<b>HYUNDAI</b> <b>Technical Service Bulletin</b>	GROUP <b>ENGINE ELECTRICAL</b>	NUMBER <b>25-EE-002H</b>
	DATE <b>APRIL 2025</b>	MODEL(S) <b>SONATA (DN8/DN8A)</b>
<b>SUBJECT:</b> MULTI-FUSE REPLACEMENT & BLOWER WIRING REPAIR

**Description:** Certain Sonata (DN8) and Sonata (DN8A) vehicles may experience issues with the air conditioning due to damaged wiring in the engine room junction box. This bulletin provides instructions to replace the multi-fuse, reroute the damaged wiring using the blower wiring kit, and replace the fuse label.

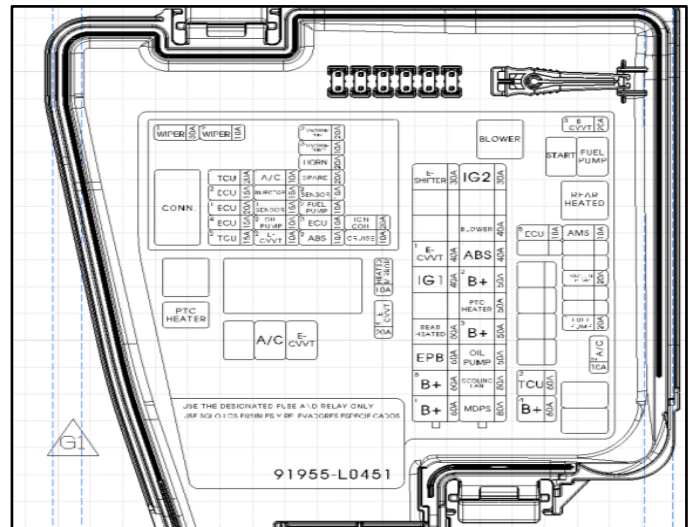
- Modified fuses (18980-09910) are replaced with new ones, while reused fuses (18980-09920) remain in place.

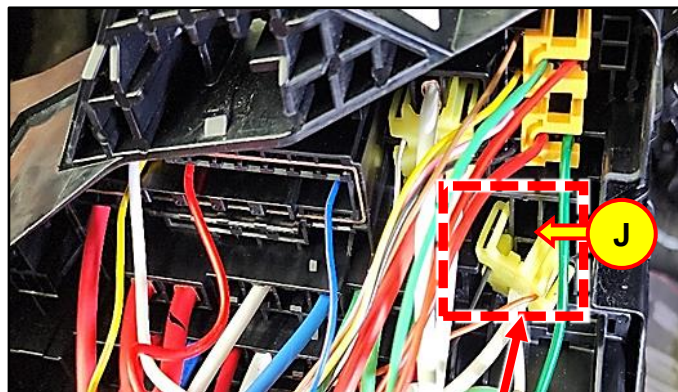
9. Cut the wiring from the removed terminal and wrap the remaining harness securely using insulating tape (I).

Relay terminal

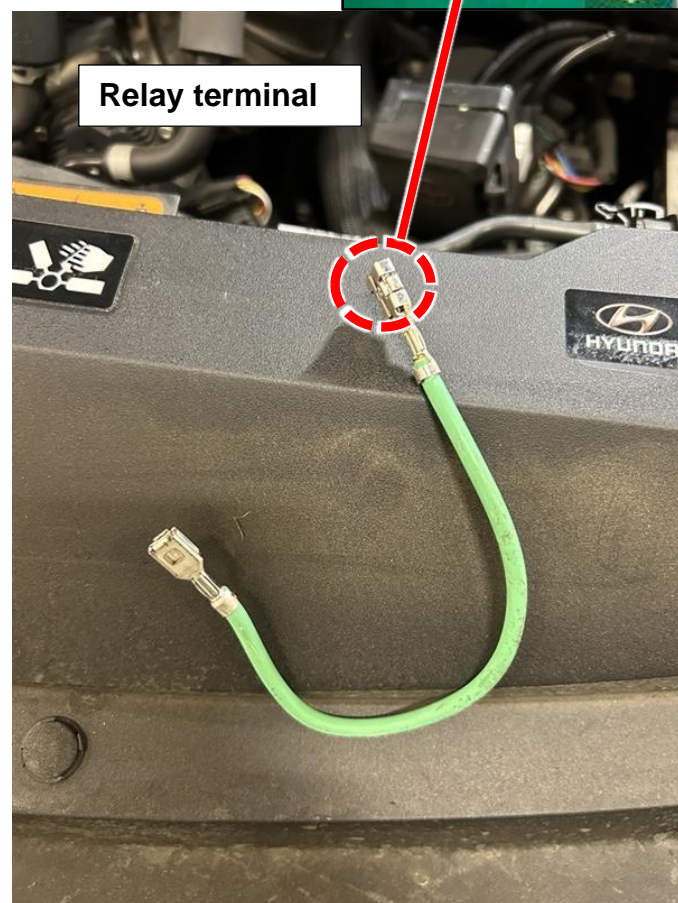
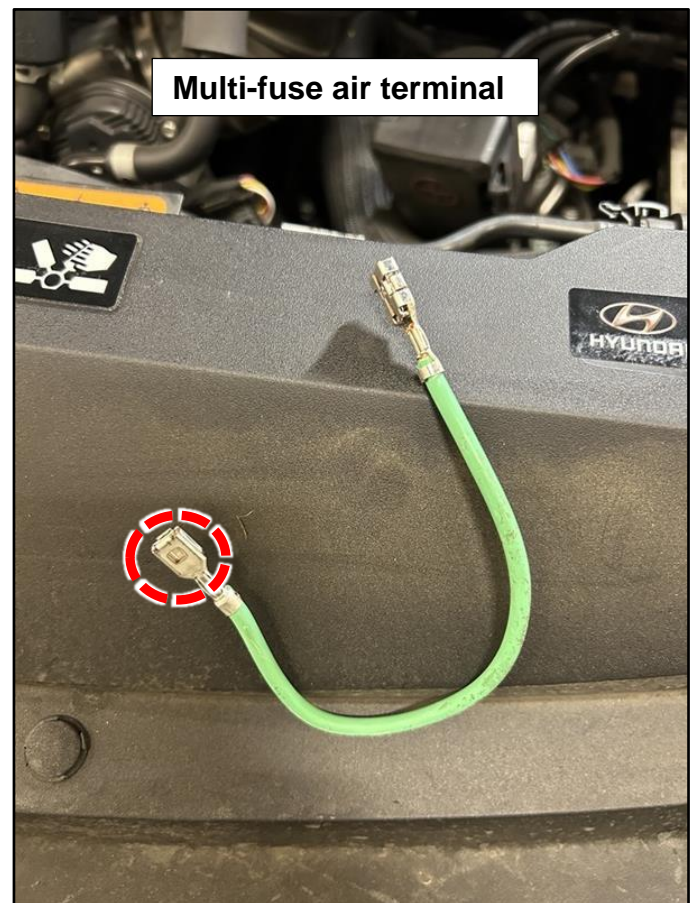
10. Install the supplied wiring terminal from the kit into the connector (J).

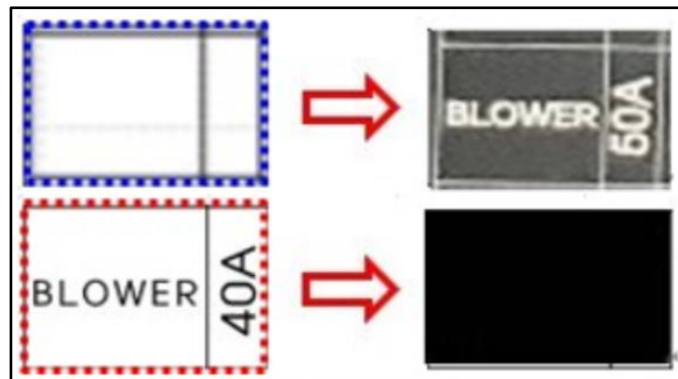
11. Install the multi-fuse air terminal with the other side of the supplied wire terminal, ensuring proper installation between the white and orange wires (K).

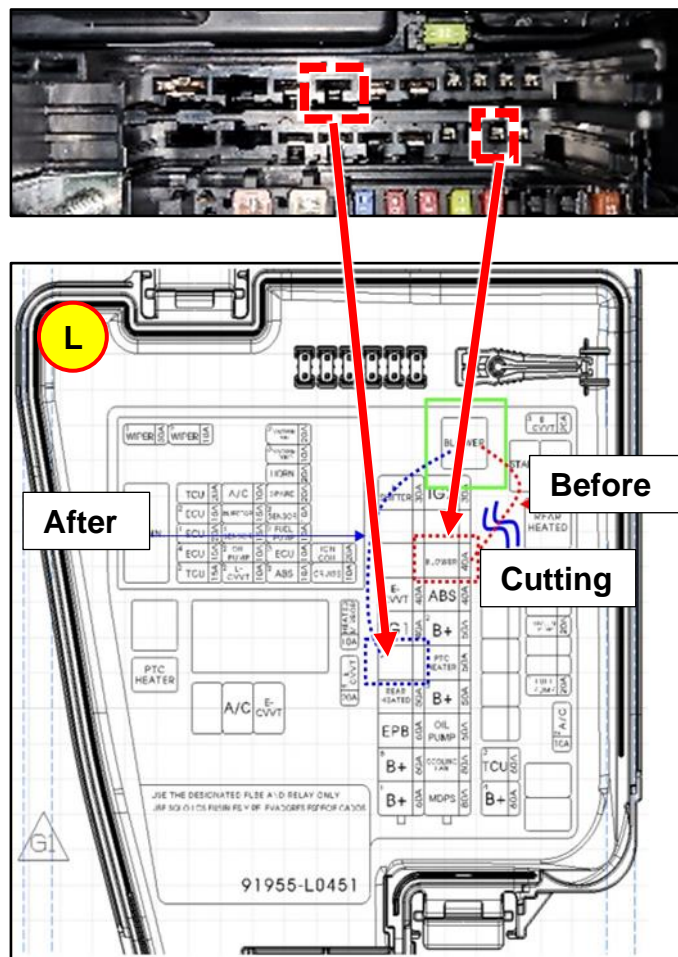
12. Place the Blank label over the existing 40A label in the red dotted area below in step 13. Place the 50A label in the blue dotted area below in step 13. (currently no label) below in step 13.

13. Reinstall parts in the reverse order of the removal. Current routing before cutting and re-routing after cutting (L).
